Dominion Nuclear Connecticut, Inc.
Rope Ferry Rd., Waterford, CT 06385

Serial No. 14-625
NLOS/WDC R0
Docket No. 50-336
License No. DPR-65

DOMINION NUCLEAR CONNECTICUT, INC.
MILLSTONE POWER STATION UNIT 2
RESPONSE TO SECOND REQUEST FOR ADDITIONAL INFORMATION REGARDING
PROPOSED TECHNICAL SPECIFICATION CHANGE FOR SPENT FUEL STORAGE

FIGURE 3.9-1D MINIMUM REQUIRED AVERAGE FUEL ASSEMBLY BURNUP AS A FUNCTION OF INITIAL ENRICHMENT TO PERMIT STORAGE IN REGION 3 (with insertion of a full length, full strength Control Element Assembly)

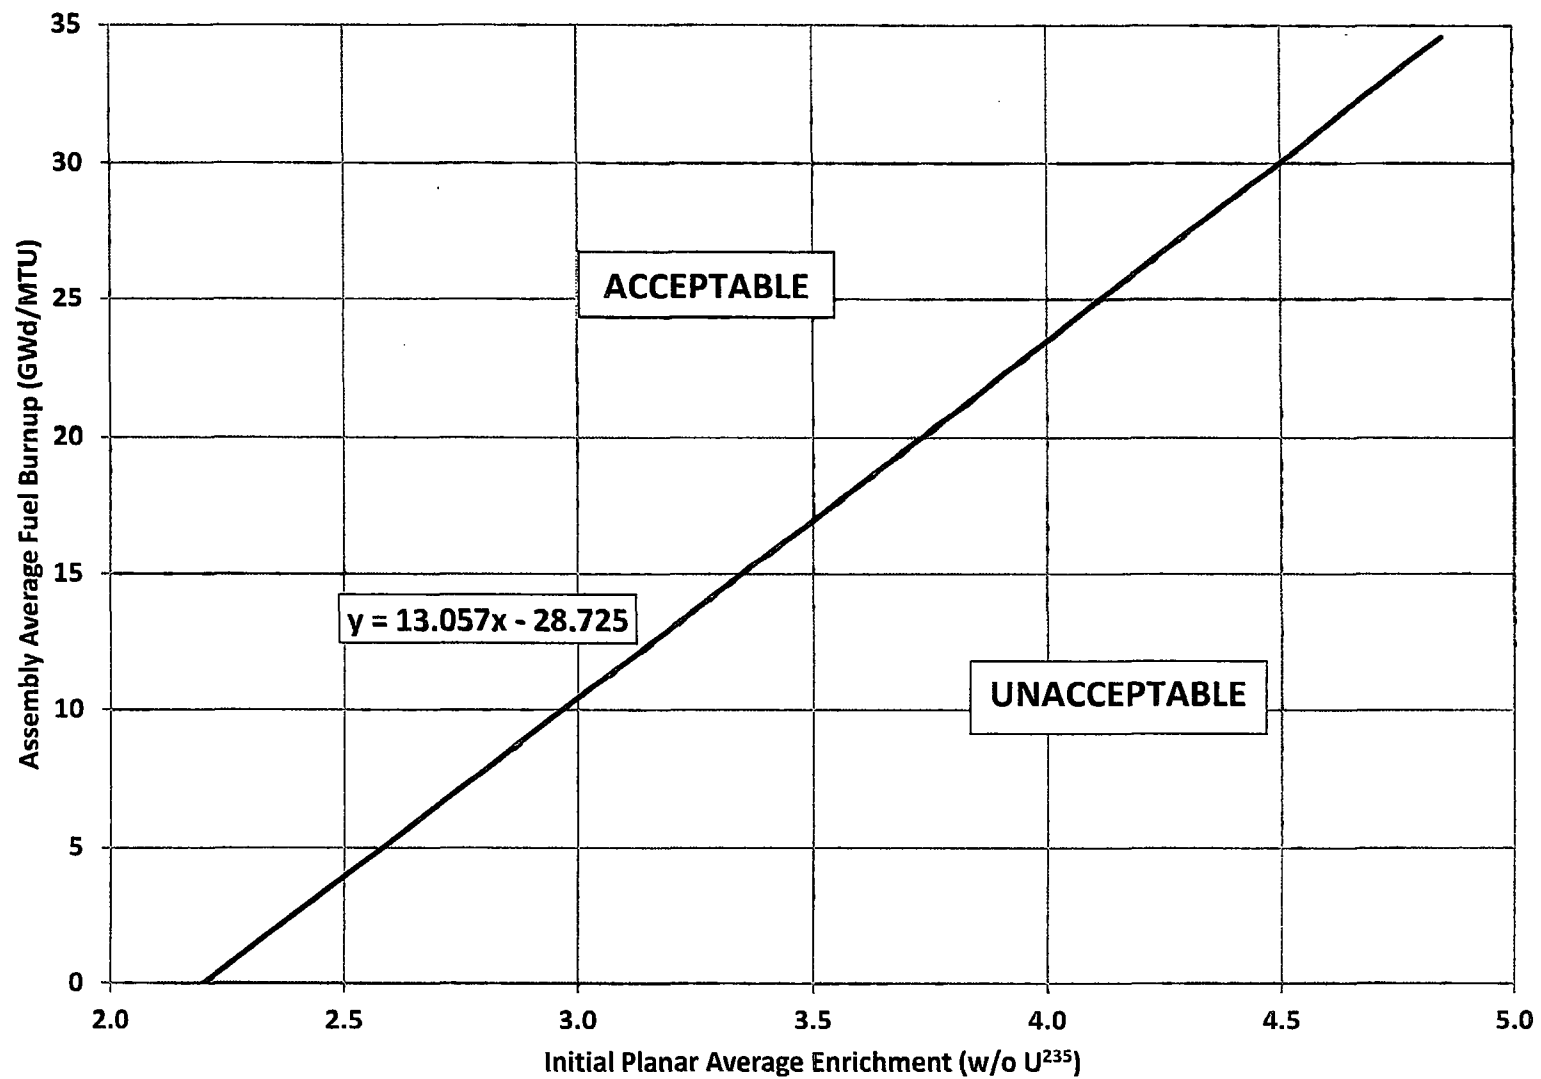
Finally, fuel assemblies utilizing Figure 3.9-1 D require that a full-length, full strength, control element assembly be inserted in the fuel assembly. (No credit is allowed for reduced-strength control element assemblies or part-length control element assemblies).

TS Figure 3.9-1D is a new figure. This figure shows the minimum required fuel assembly burnup as a function of initial planar average enrichment to permit storage of fuel assemblies containing a CEA in Region 3.

FIGURE 3.9-1E MINIMUM REQUIRED AVERAGE FUEL ASSEMBLY BURNUP AS A FUNCTION OF INITIAL ENRICHMENT TO PERMIT STORAGE IN REGION 4

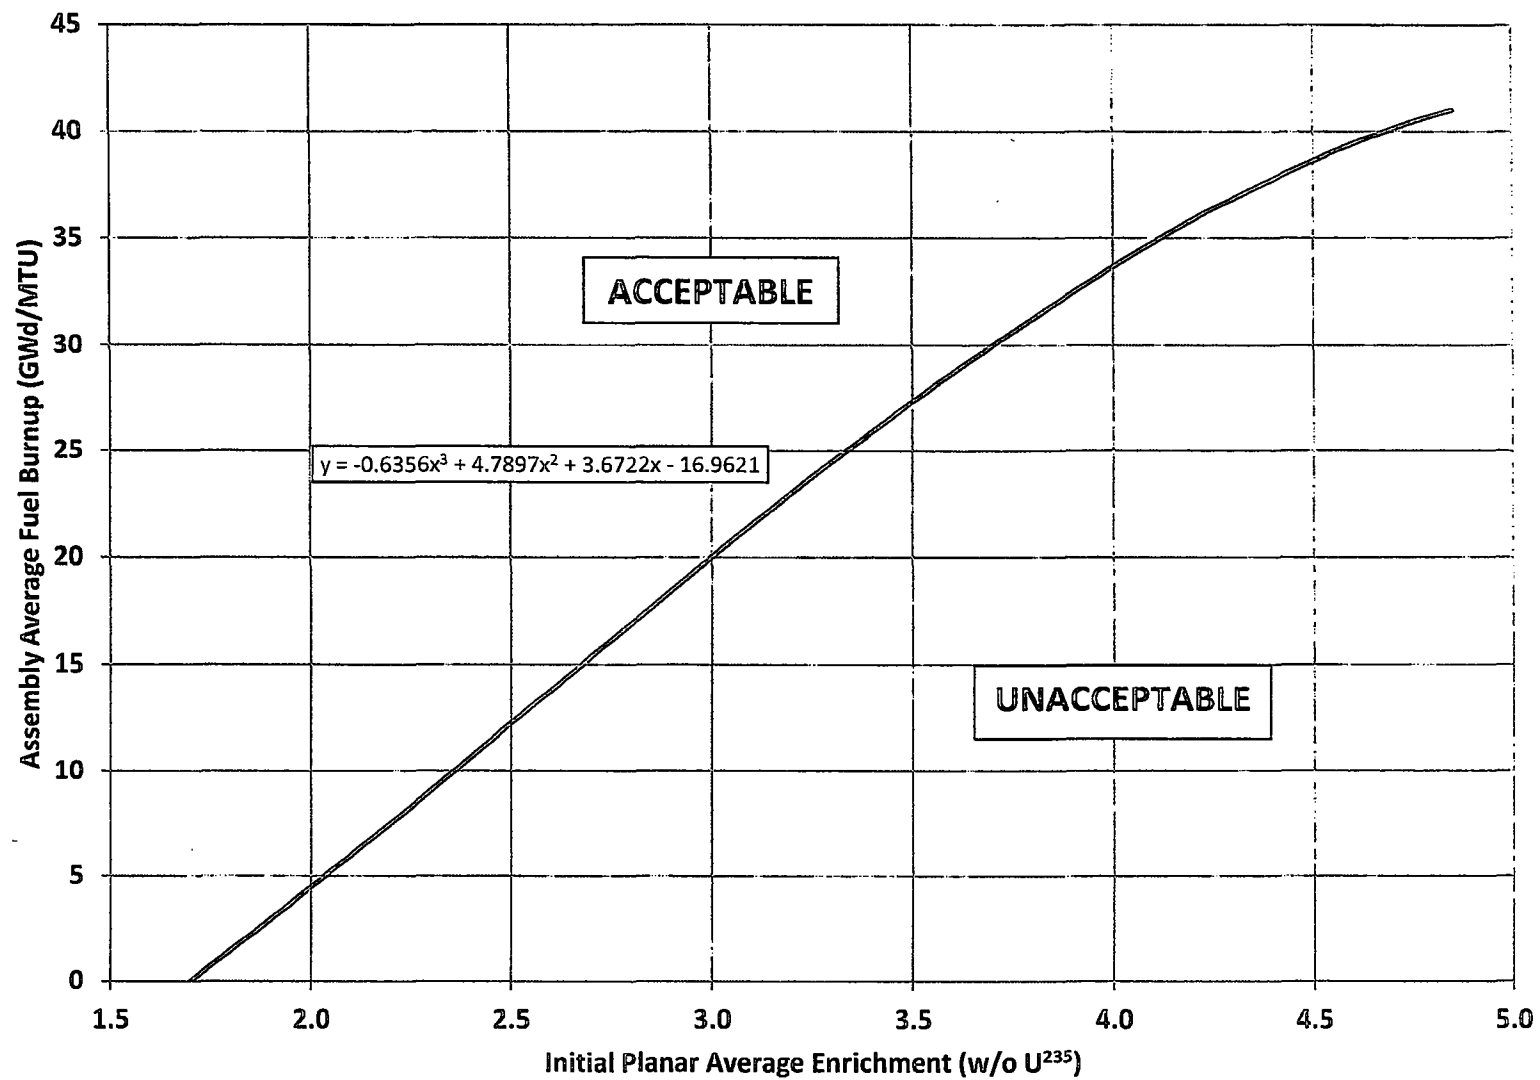
TS Figure 3.9-1E is a new figure. This figure shows the minimum required fuel assembly burnup as a function of initial planar average enrichment to permit storage of fuel assemblies in Region 4.

SPENT FUEL POOL ARRANGEMENT
FIGURE 3.9-2
(NOT TO SCALE)

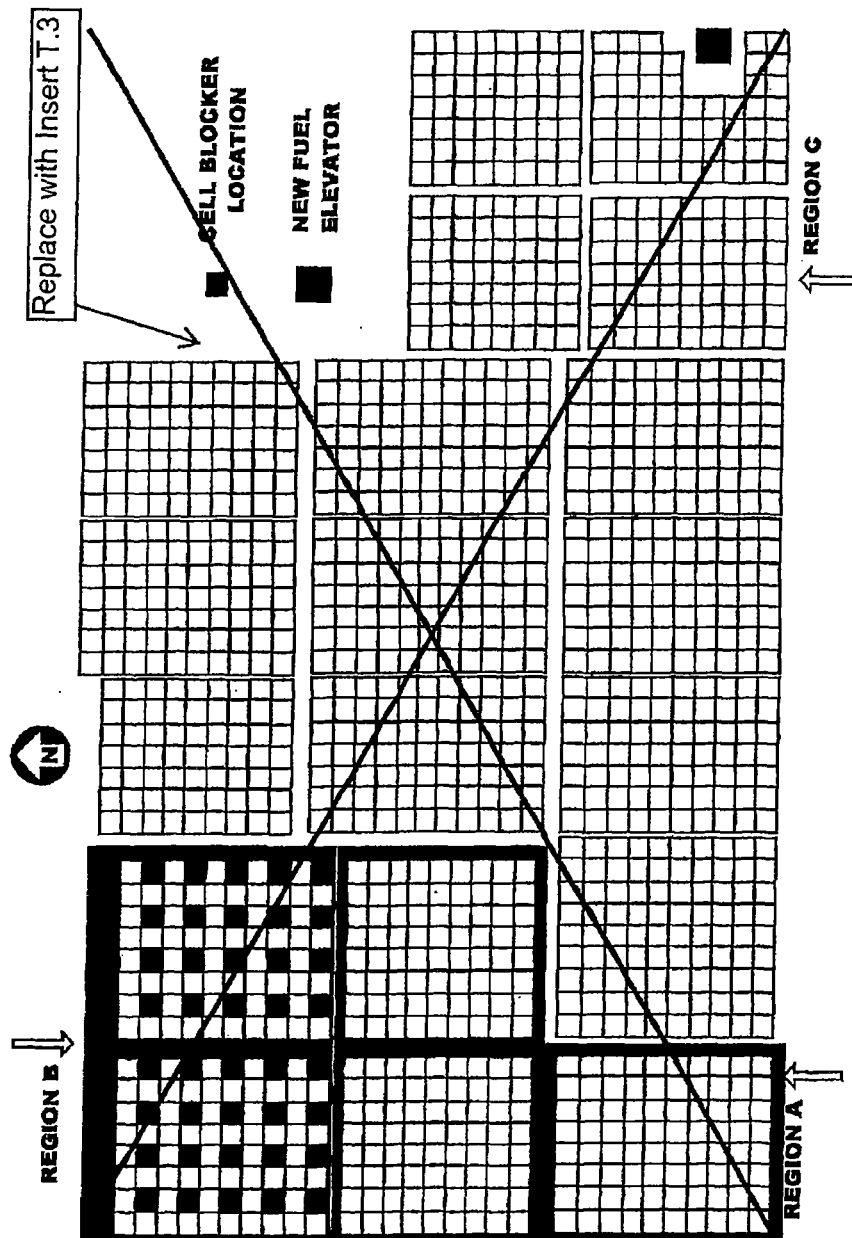
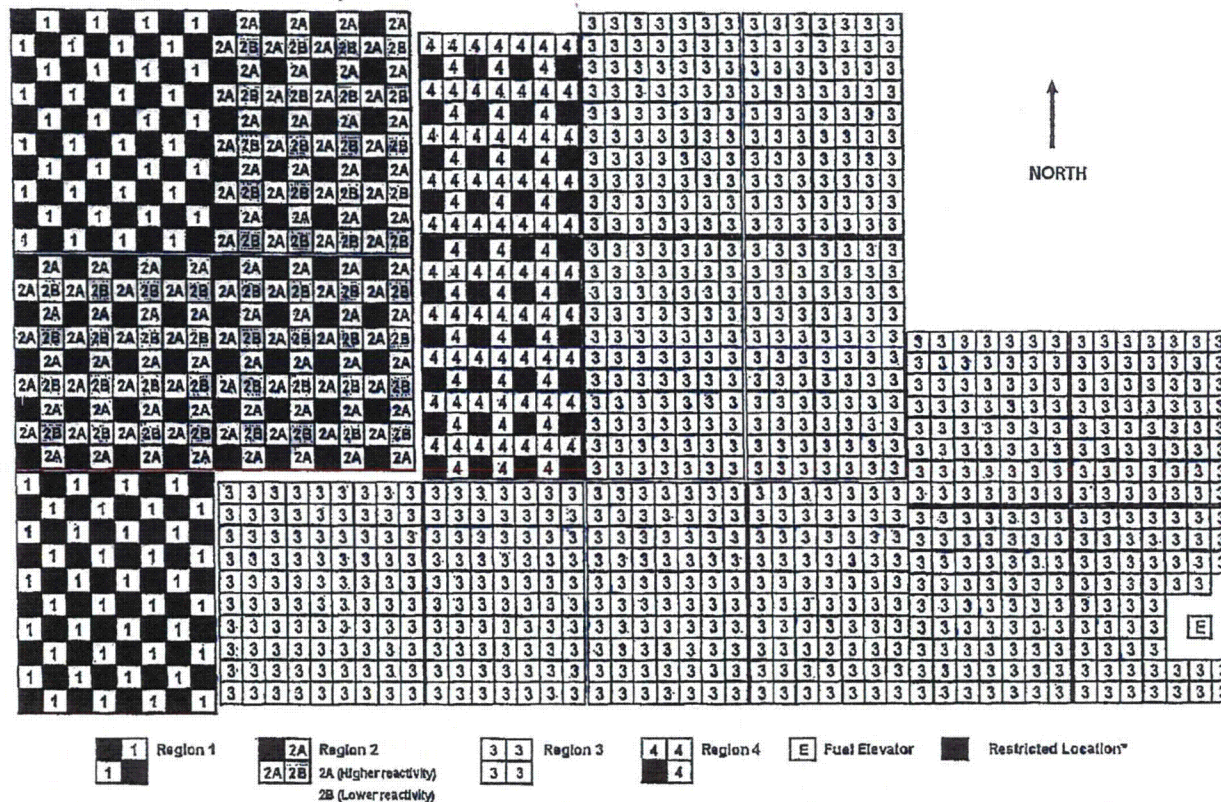
Attachment 2 includes a new Figure 3.9-2 showing the SFP layout. A note on the figure states "A Restricted Location may contain non-standard fuel configurations or components, or is empty." It is not clear from the criticality analysis that it is safe to store an unspecified non-standard fuel configuration in the "Restricted Locations." Please justify using the "restricted locations" for storing non-standard fuel configurations.

TS Figure 3.9-2 is revised. This figure illustrates the new region definitions and storage patterns of the fuel storage racks. It also discusses the requirement that Restricted Locations are to remain empty.

An NSFC analysis is presented in Attachment 4 of this letter. The analysis qualifies NSFCs for storage in locations intended to store fuel. None of the existing NSFCs have been qualified for storage in a Restricted Location. In addition, this analysis does not generically support storage of non-fuel items in Regions 1, 2, or 4 Restricted Locations with the exception of full length, full strength CEAs (control rods). Although CEAs are analyzed for storage in Restricted Locations, for simplicity and clarity, the note on Figure 3.9-2 will be changed to "Restricted Locations shall remain empty of fuel and non-fuel components." Non-fuel items can be placed in any location intended for fuel, including in a location intended for fuel in which the poison box has been removed.

DELETE - Figure to be deleted because existing Consolidated Fuel Storage Boxes have been analyzed for storage in all regions except for Restricted Locations.

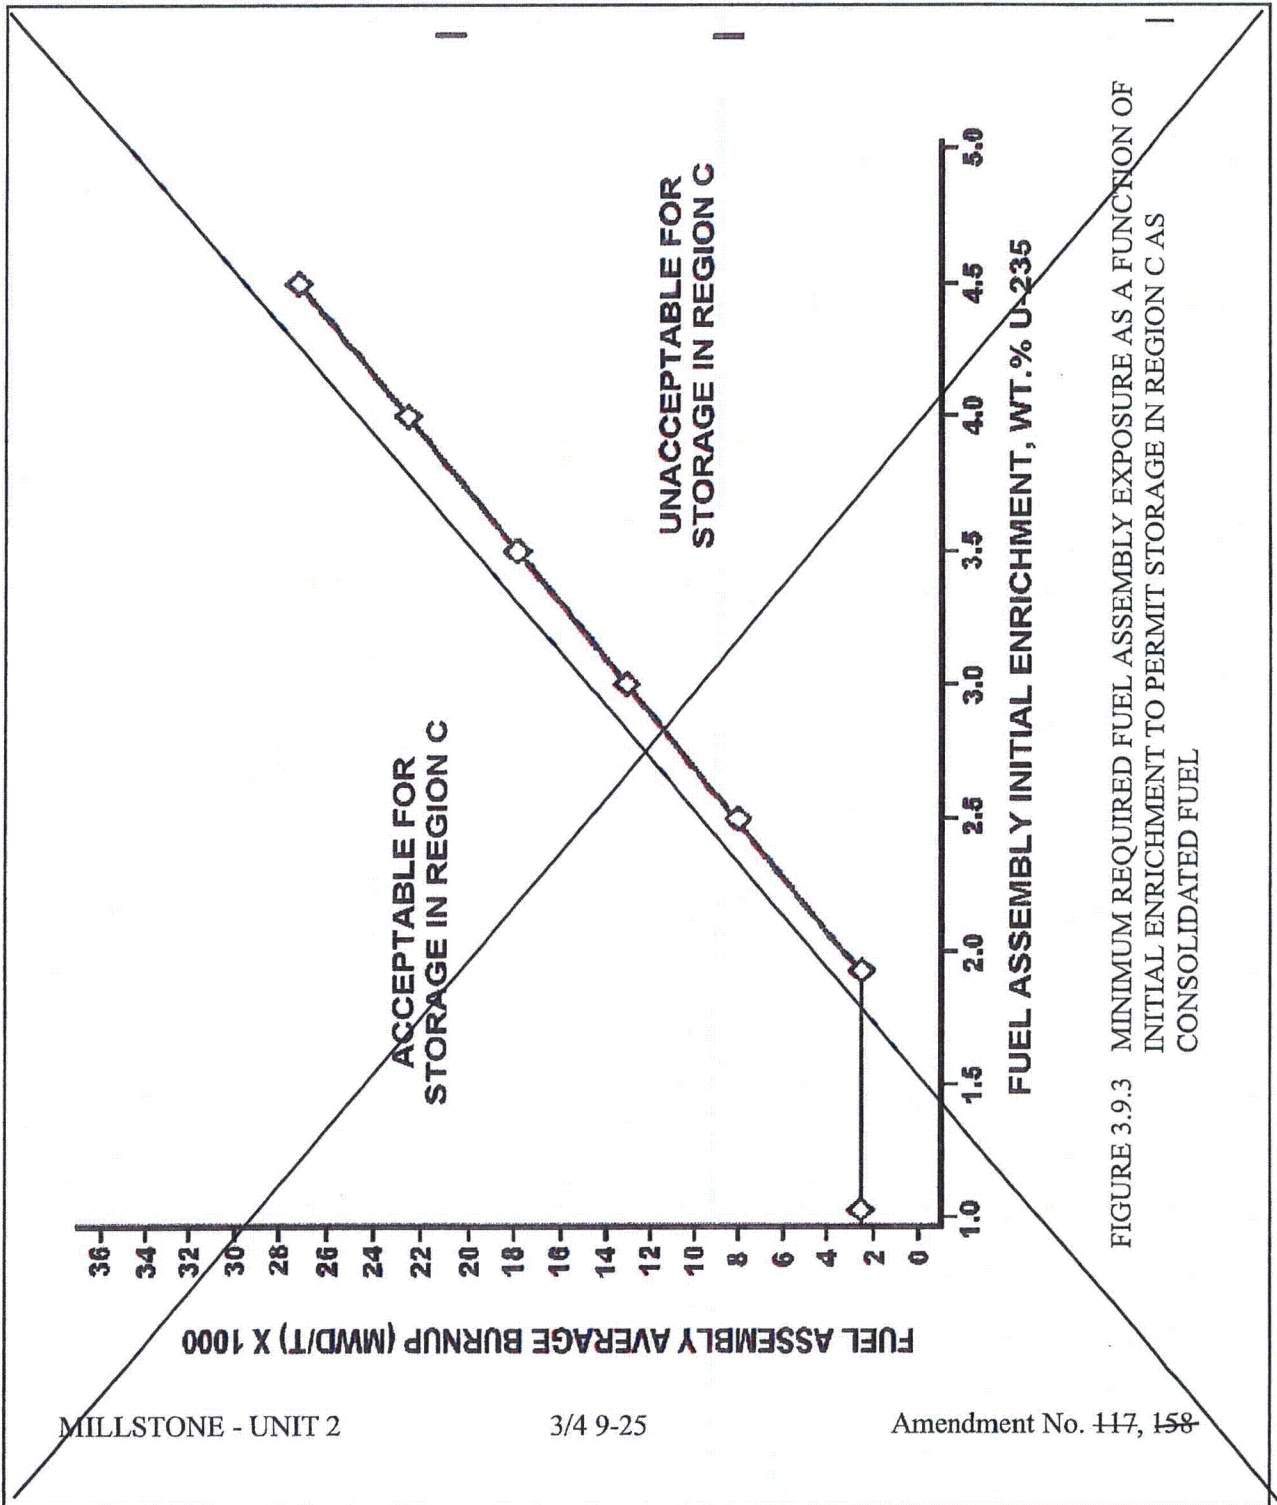
Figure 3.9-3 is deleted because consolidated fuel is now considered a type of Non-standard Fuel Configuration. Non-standard Fuel Configurations are analyzed on an individual basis. Each Non-standard Fuel Configuration must have a criticality analysis which may allow storage in one or multiple regions, and which may or may not require rodlets or a CEA if stored in Region 3.

FIGURE 3.9-4 MINIMUM REQUIRED FUEL ASSEMBLY EXPOSURE AS A FUNCTION OF INITIAL ENRICHMENT TO PERMIT STORAGE IN REGION A

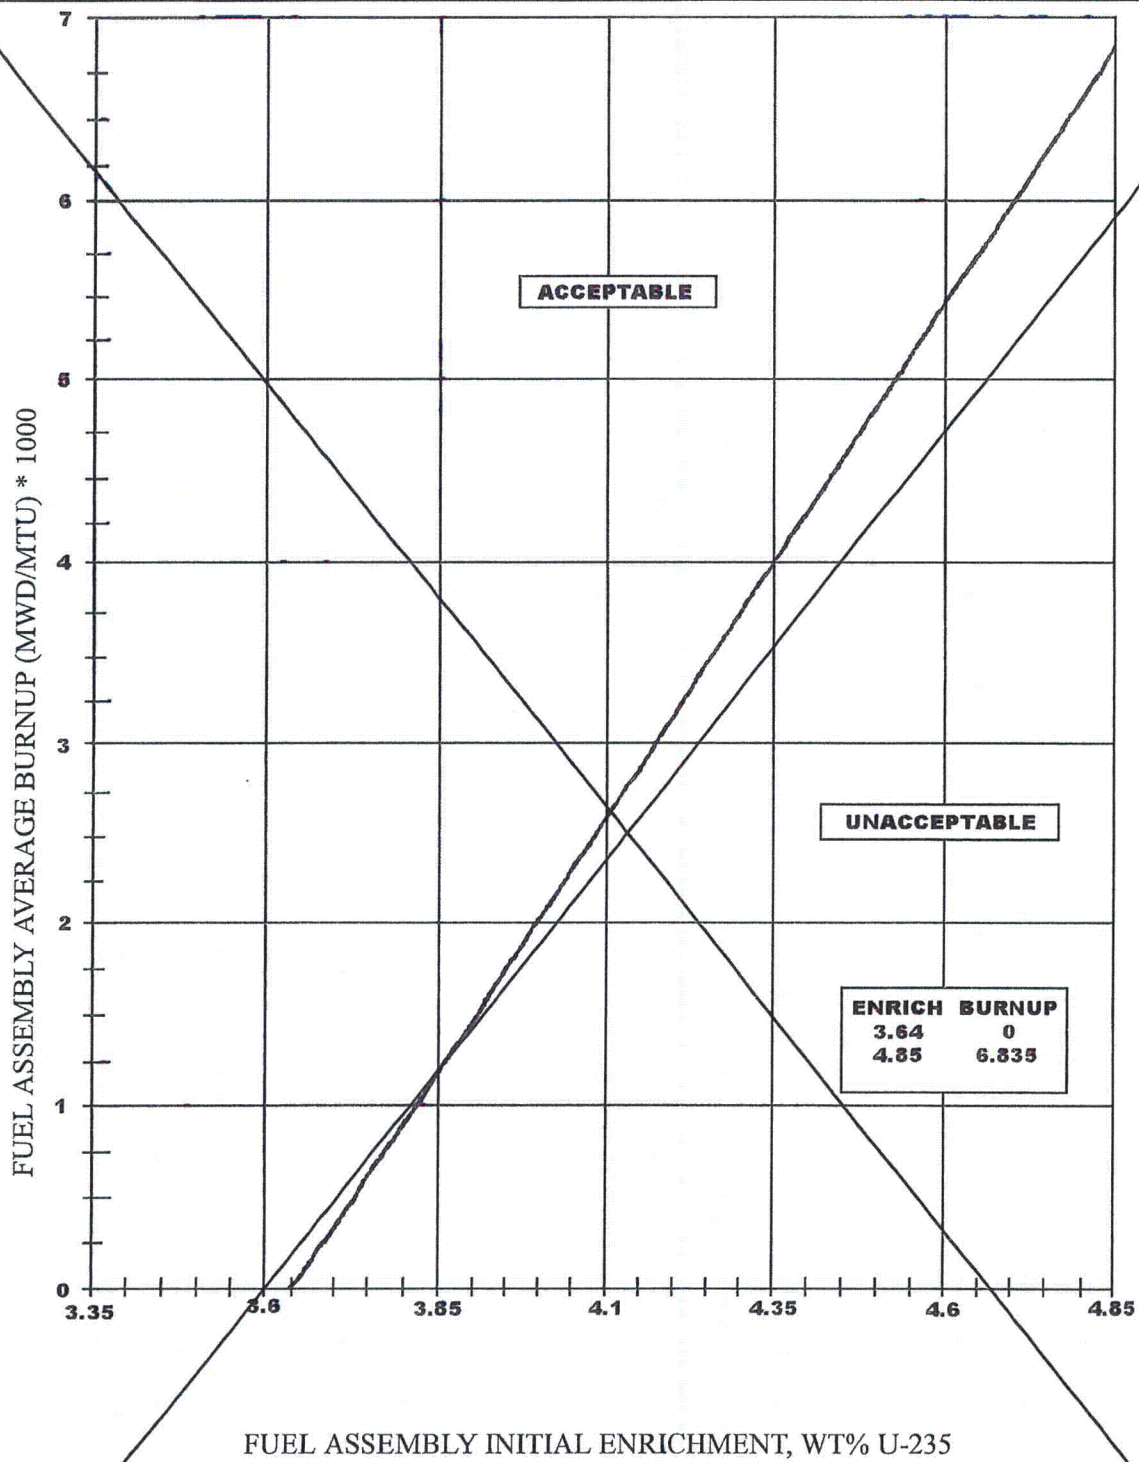
Figure 3.9-4 is deleted because Region 1 does not use an enrichment/burnup curve.
